HIGHWAY WORK PROPOSAL

Proposal Number: **040**

<u>STATE ID</u>	<u>FEDERAL ID</u>	<u>PROJECT DESCRIPTION</u>	<u>HIGHWAY</u>	<u>COUNTY</u>
1196-04-77	N/A	New Auburn - Rice Lake, B-03-14,16,18,20,26,30,37,218	USH 053	Barron

Addendum No. 01
ID 1196-04-77
Revised Sheet 77
March 3, 2025

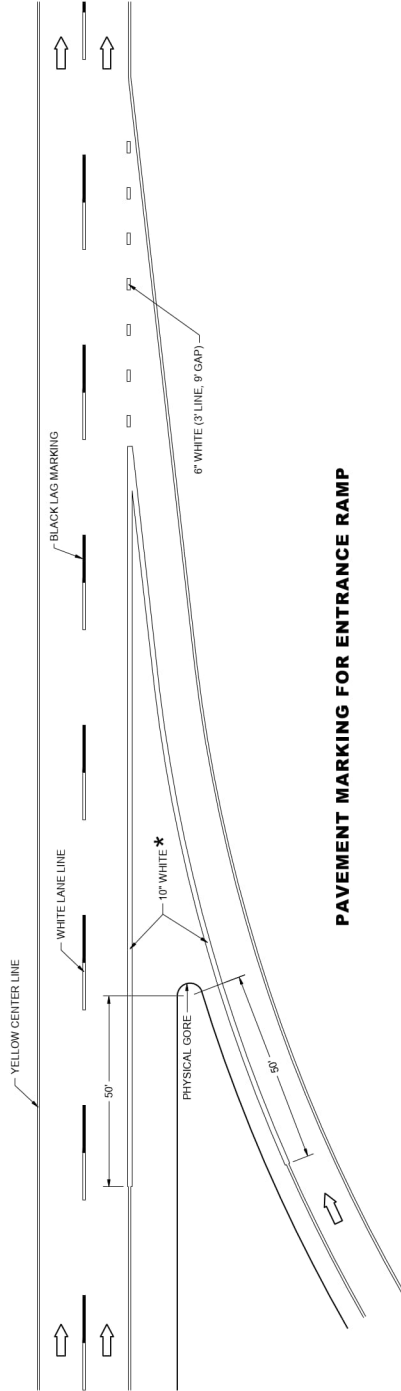
Revised Plan Sheets	
Plan Sheet	Plan Sheet Title (brief description of changes to sheet)
77	Miscellaneous Quantities: Temporary Marking Line miscellaneous quantity table update (643.3170 Temporary Marking Line Epoxy 6-Inch quantity between Station 843+23 SB and Station 856+36 SB updated to account for 3-foot segment/9-foot gap within lane drop).
296	Structure Plan Sheet: B-3-26 (eliminated north abutment bearing removals).
297	Structure Plan Sheet: B-3-26 (eliminated north abutment bearing removals).
